Access Compliance Report

Public Rights-of-Way

Intersection ID: 3253	Main Street: SUTTONVIEW_DR	Cross Street: SHADOW_PINE_DR	Location: NE
ADA ID: FD559739C8A7	Ramp Type: Perp	Initial Pass/Fail: Pass	Overall Compliance: No
		Severity Score: 5.25

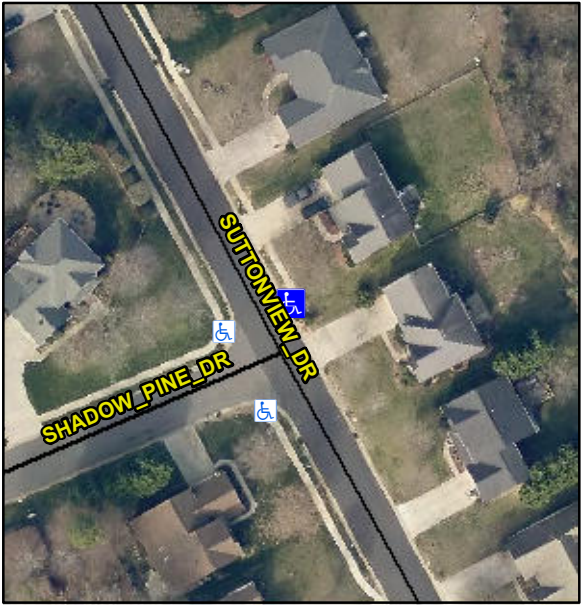
Codes/Mitigation Info/Possible Solution			Field Measurements/Component Compliance		
	Possible Solutions:		Compliance	Description	Data
	Remove & Replace Entire Ramp.		Yes	Ramp Length (in)	48.5
			Yes	Ramp Width (in)	48.0
			N/A	Flare Type LT	Sloped
			N/A	Flare Slope LT (%)	3.7
			N/A	Flare Traversable LT?	Yes
			Yes	Landing Length (in)	48.0
			Yes	Landing Width (in)	48.0
			Yes	Landing Slope (%)	0.8
			No	Landing X Slope (%)	4.5
			N/A	Landing Curb? (Y/N)	No
			N/A	Shared Landing?	No
			Yes	Gutter Ponding?	No
			Yes	Gutter Lip Ht (in)	0.0
			N/A	Painted X Walk1?	No
				X Walk 1 Direction	To W
			N/A	X Walk 1 Width (in)	N/A
				X Walk 1 Slope (%)	5.7
				X Walk 1 X Slope (%)	4.0
			N/A	Ramp inside XWalk1?	N/A
<p>Surveyor Notes:</p> <p>N/A</p> <p>PROW/ADA:</p> <p>R304.5.3, R304.2.3</p>			N/A	Flare Type RT	N/A
			No	Flare Slope RT (%)	12.9
			N/A	Flare Traversable RT?	Yes
			Yes	DWS Provided?	Yes
			Yes	DWS Contrast?	Yes

Yes	DWS Length (in)	25.5
			Yes	DWS Full Width?	Yes
			Yes	DWS Offset (in)	2.0
			Yes	Gutter Slope (%)	3.6
			Yes	Gutter X Slope (%)	3.9
			N/A	Painted X Walk2?	N/A
				X Walk 2 Direction	N/A
			N/A	X Walk 2 Width (in)	N/A
				X Walk 2 Slope (%)	N/A
				X Walk 2 X Slope (%)	N/A
			N/A	Ramp inside XWalk2?	N/A
			N/A	Clear Space?	Yes
			N/A	Clear Space to XWalk (in)	N/A
			Yes	Storm Grate/Utility Hazard?	No
<p>Total Cost:</p> <p>\$ 1850.00</p>				Storm Grate/Utility Type	
			N/A		N/A
			Yes	Surface Condition? (G/P)	Good
